Document 00910

ADDENDUM NO. Date of Addendum: \(\square\frac{\pi_{\infty}}{20} \)

PROJECT NAME: Almeda Road Paving and Drainage Improvements Old Spanish Trail to South MacGregor Way PROJECT NO: WBS No. N-000806-0001-4; CSJ No. 0912-72-072 BID DATE: May 28, 2015 J. Timothy Lincoln, P.E., City Engineer FROM:

TO: **Prospective Bidders**

FOR CITY OF HOUSTON USE ONLY N-000806-0001-4 DRAWING SCALE VERT: AS NOTED HORZ: AS NOTED CITY OF HOUSTON PM MICHELLE RANDON, P.E. SHEET NO.22 OF 271

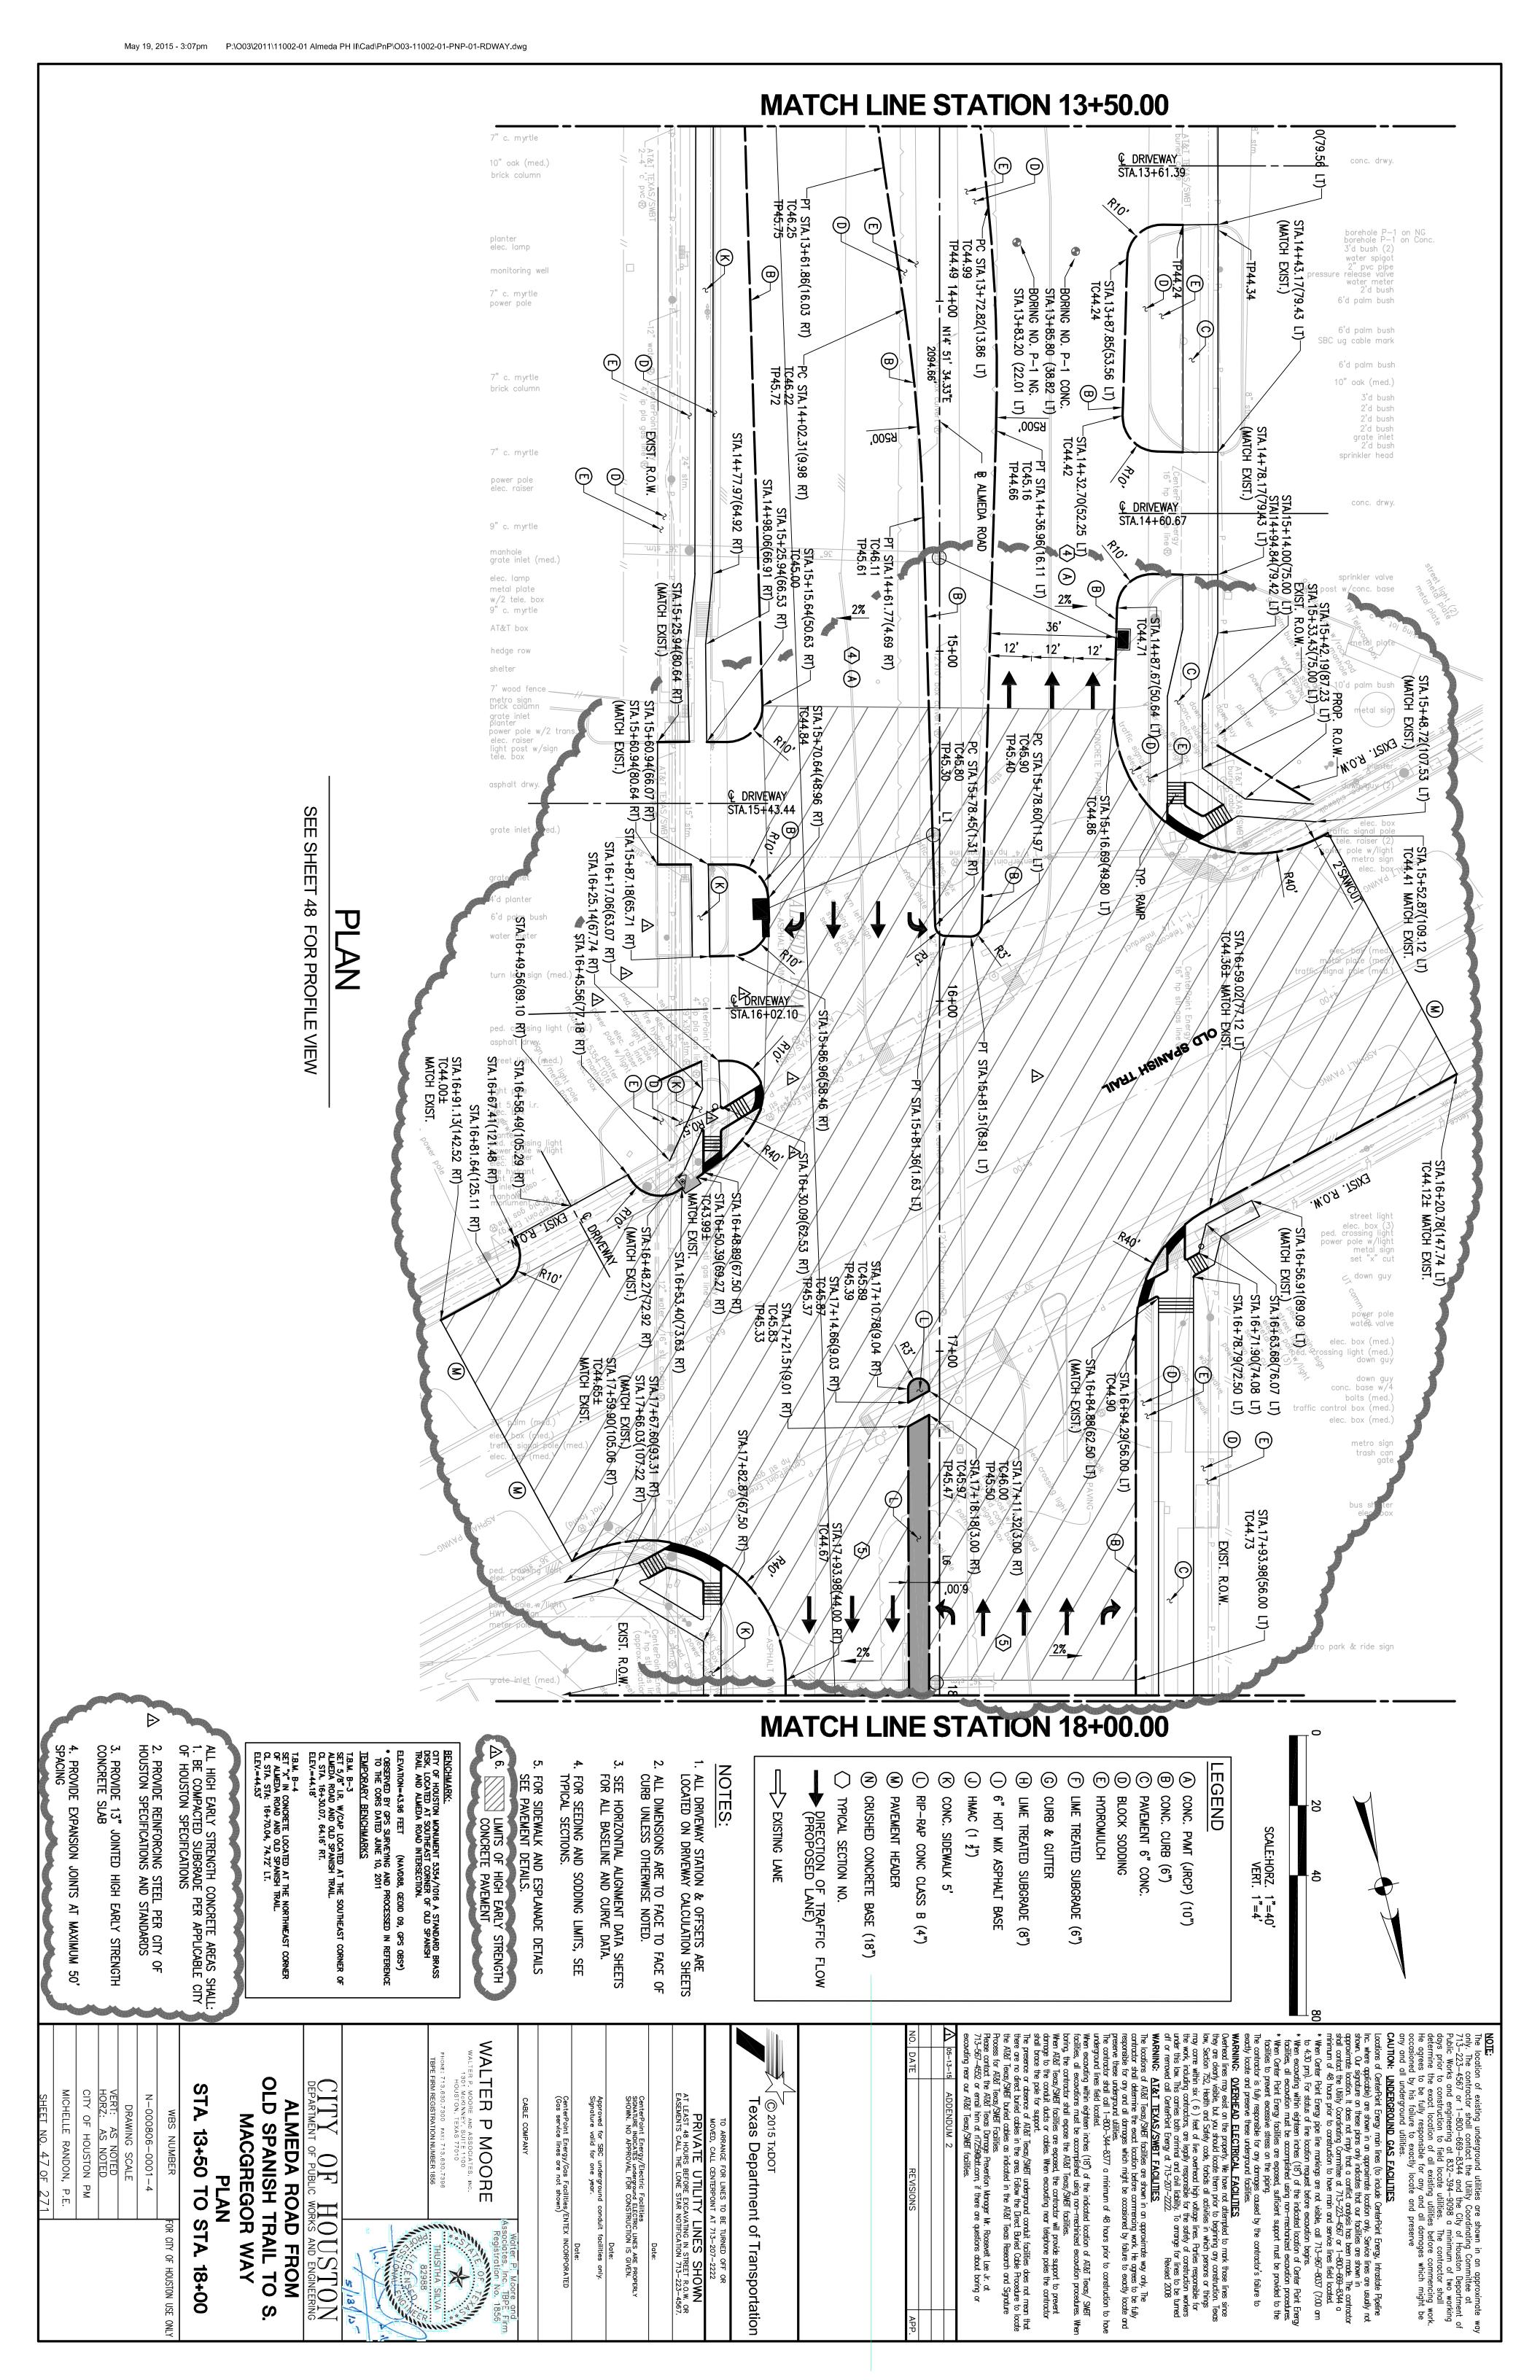
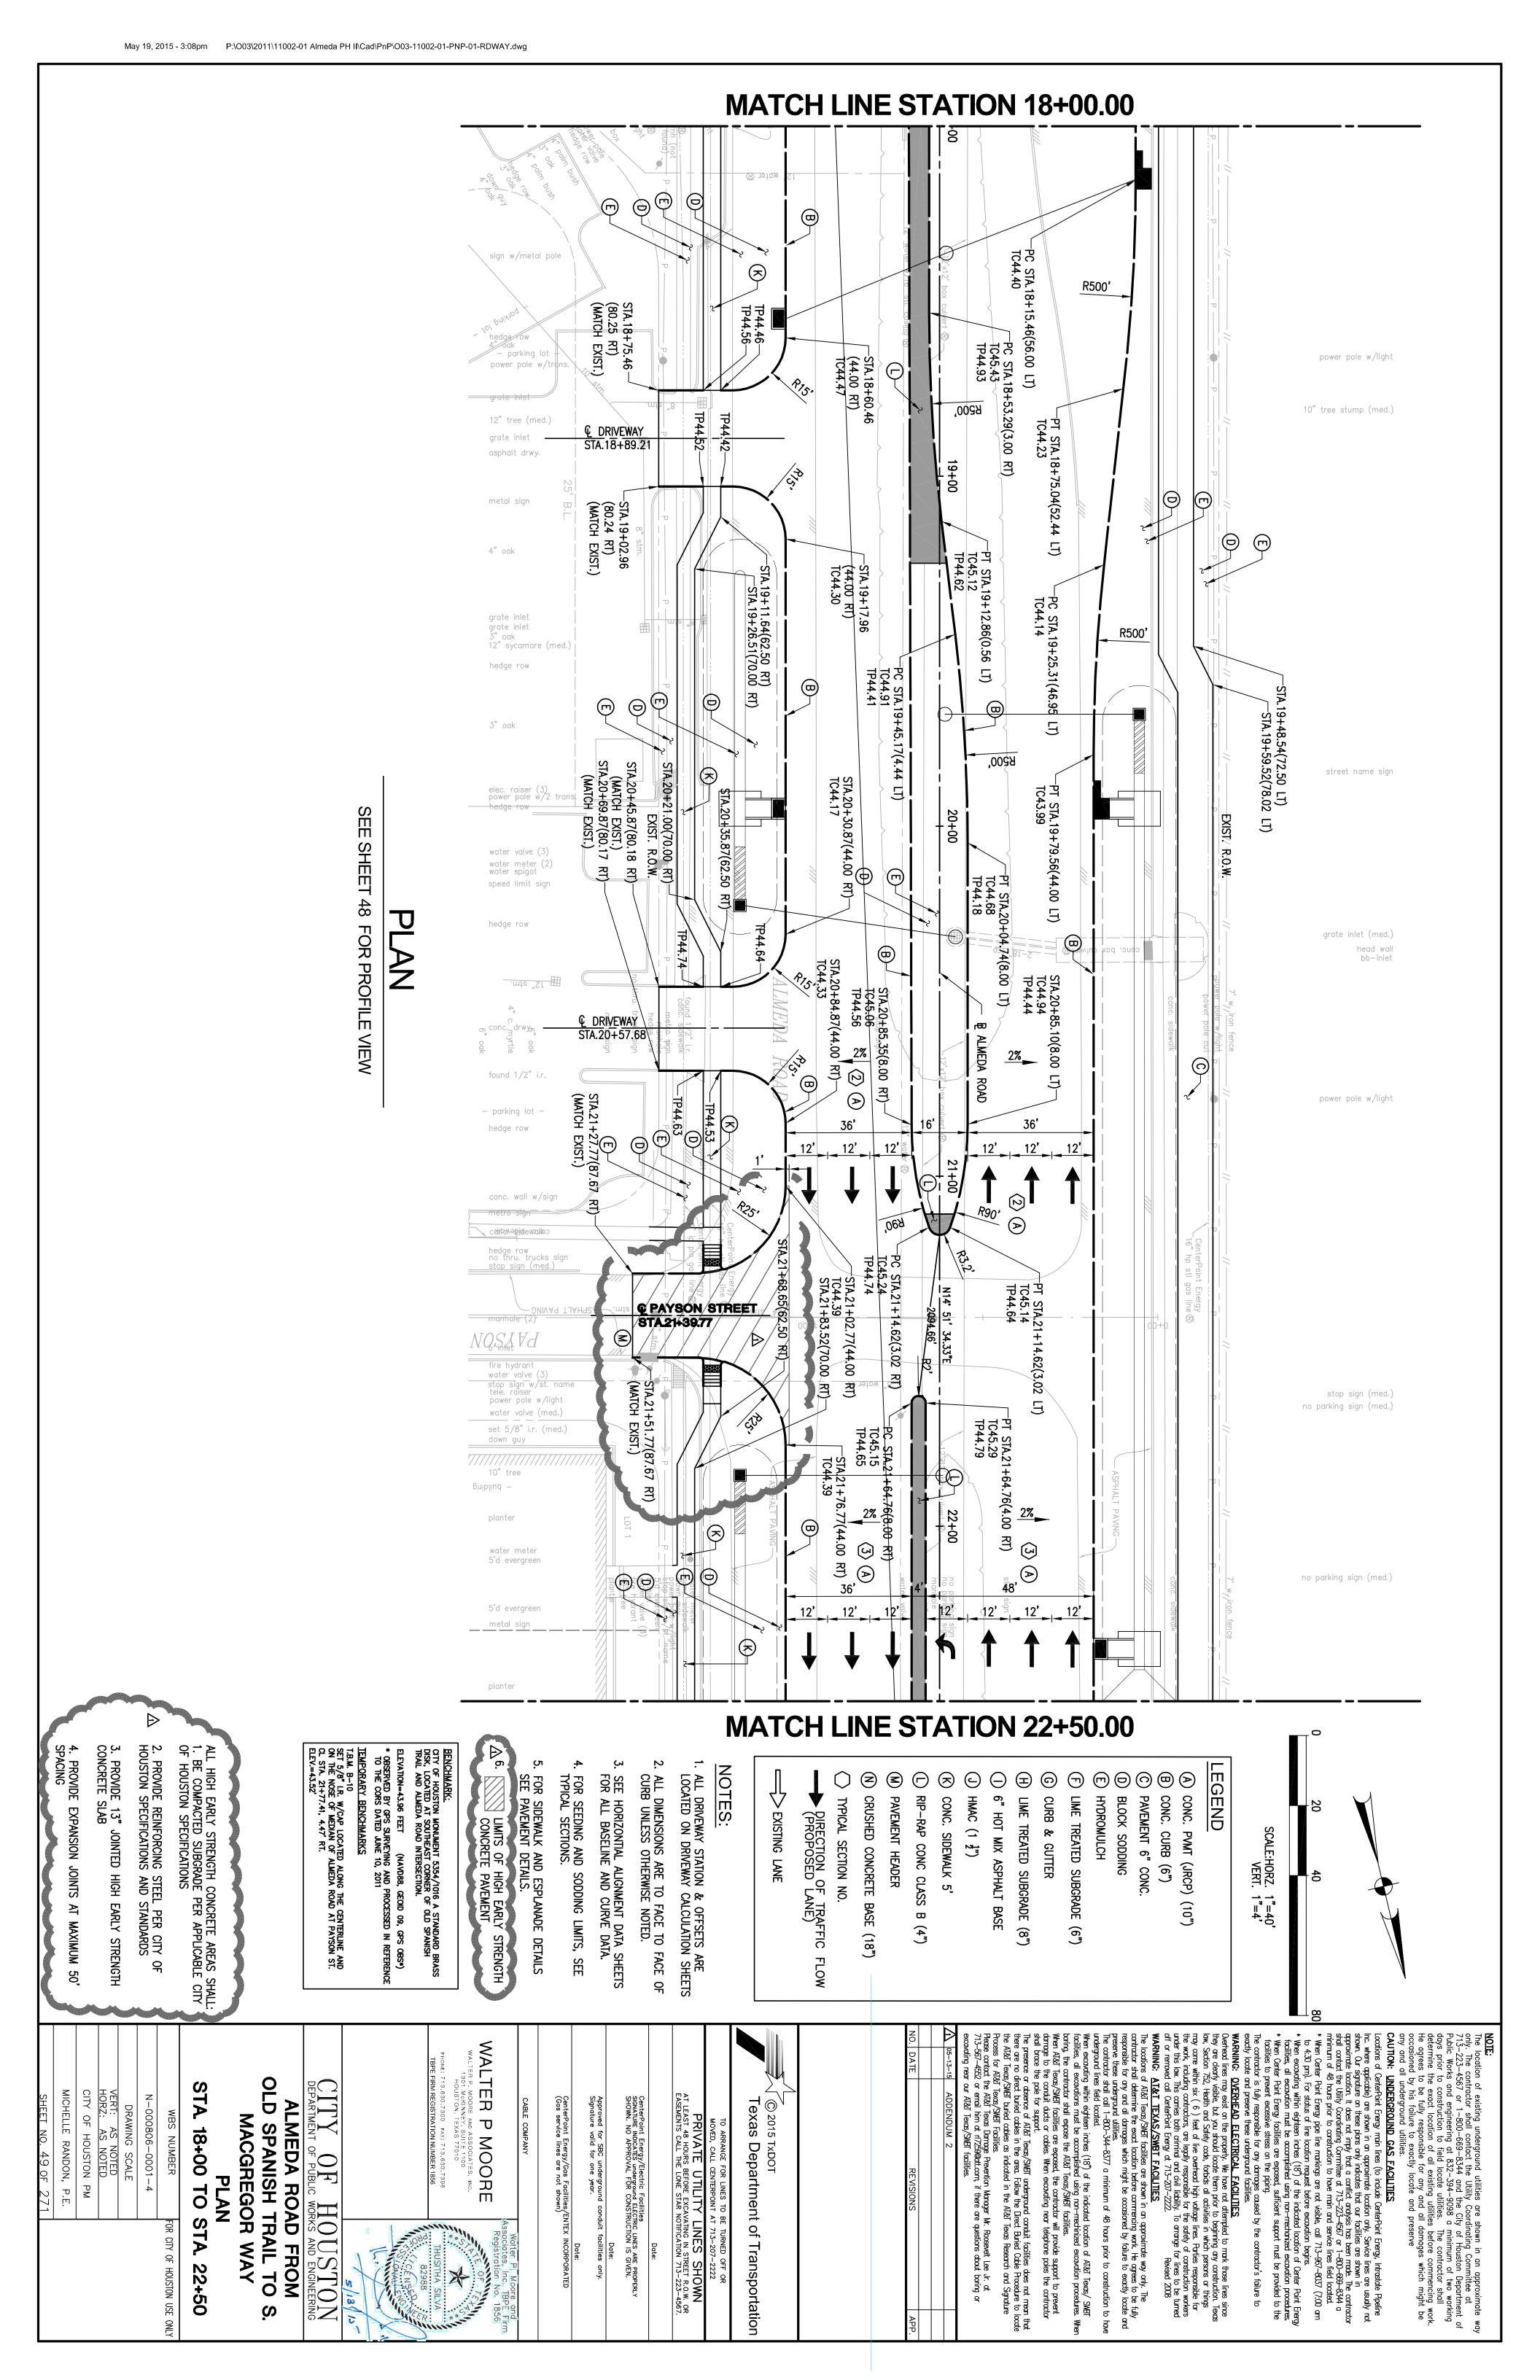
- 1. Sheet 21- Revised Holcombe Boulevard typical section, STA 6+37.98 to END PROJECT, to reflect added pavement and sidewalk reconstruction.
- 2. Sheet 22 Revised DEMOLITION QUANTITY.
- Sheet 22 A Revised STORM SEWER & STREET & BRIDGE QUANTITY
- 4. Sheet 47 Added driveway at station 16+04.59 & added shaded area to reflect limits of High Early Strength Concrete placement limits.
